Revisions to Electric Reliability Organization Definition of Bulk Electric System and Rules of Procedure; Proposed Rule

[Docket Nos. RM12-6-000 and RM12-7-000]

Revisions to Electric Reliability Organization Definition of Bulk Electric System and Rules of Procedure**AGENCY:** Federal Energy Regulatory Commission, DOE.**ACTION:** Notice of proposed rulemaking.

Figure 1**Two Radial Systems Eligible for Exclusion E1**

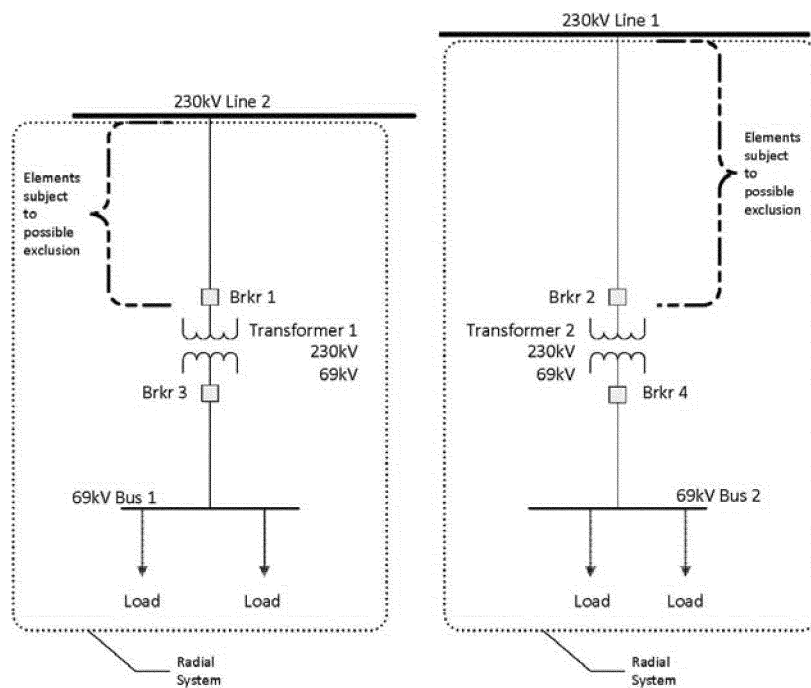
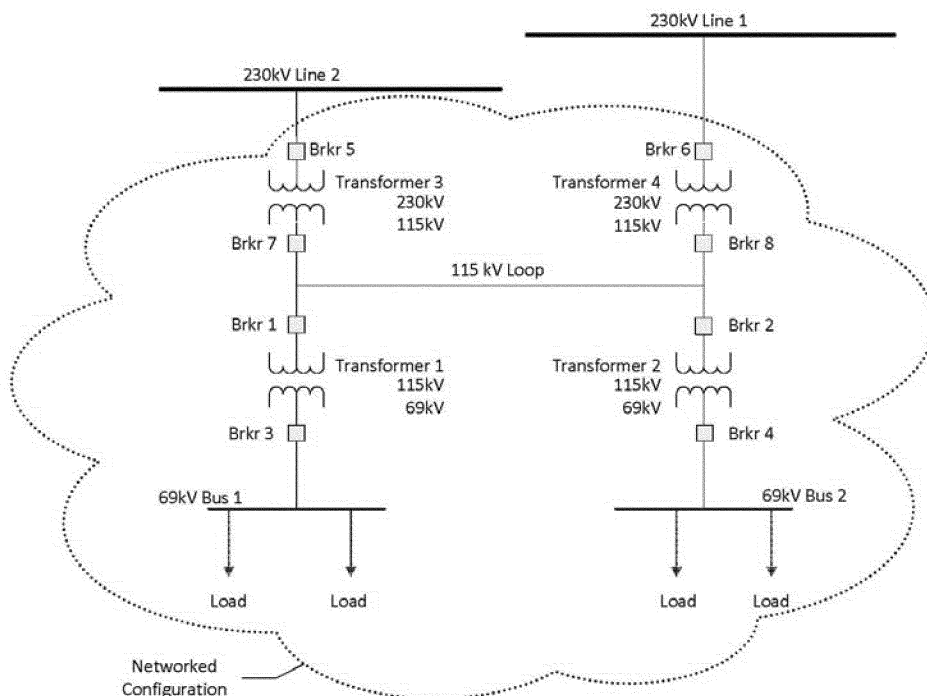
79. Figure 1 below depicts facilities configurations in which all of the 230 kV and 69 kV transmission elements emanate from a single point of connection of 100 kV or higher. The Commission seeks comment on whether each of the radial systems shown in figure 1, the 230 kV elements above each transformer to the point of connection to each 230 kV line, respectively, are excluded from the bulk electric system pursuant to exclusion E1.

Figure 2**Networked Configuration w/115 kV Loop**

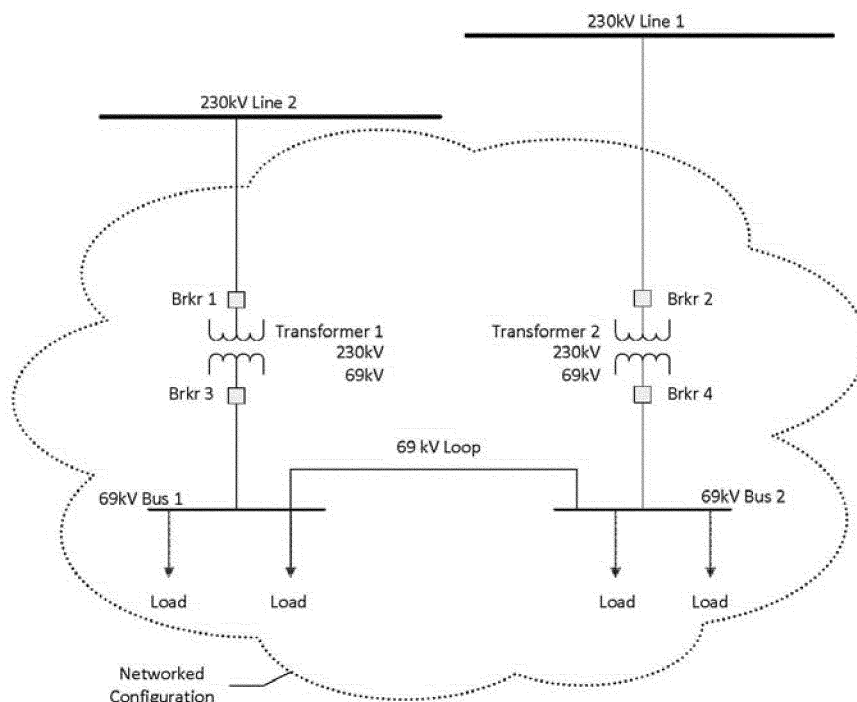
80. Another scenario shown in figure 2 below depicts a configuration containing a 115 kV loop, with the configuration emanating from two points of connection of 100 kV or higher. We seek comment whether, in

this configuration, the 115 kV and 230 kV elements above Transformers 1 and 2 to the points of connection to the two 230 kV lines would be excluded from the bulk electric system pursuant to exclusion E1. Is the configuration

shown in figure 2 more appropriately analyzed pursuant to the "local network" exclusion E3 and, if so, what if any elements operated at or above 100 kV would be excluded pursuant to exclusion E3?

Figure 4
69 kV Networked Configuration with Normally Open Switch

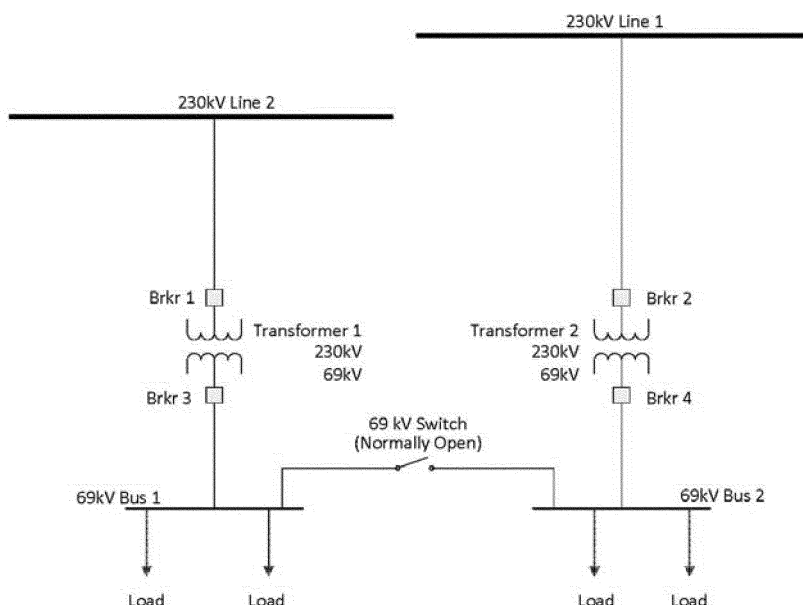
86. Figure 4 below illustrates a configuration with a normally open switch.

NERC states that “[t]he concept that two sets of radial facilities that are normally unconnected to each other should be subject to * * * applicable Reliability Standards during the limited time periods when they are connected by the closing of the normally open switch in the maintenance-related or outage-related circumstances described above would be fundamentally impractical and unworkable (from both the entity’s perspective and the ERO’s perspective), and would misapprehend this very common, reliability-driven facilities configuration.”¹⁰⁴

Figure 5

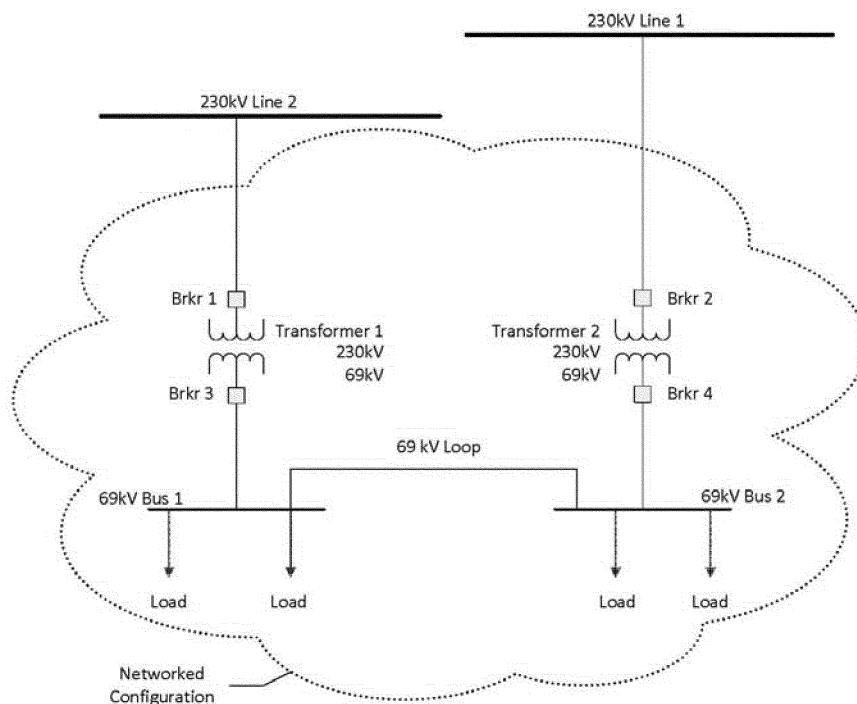
The configuration in figure 5 depicts a group of elements that are contiguous through a 69 kV loop. We seek comment whether the configuration in figure 5
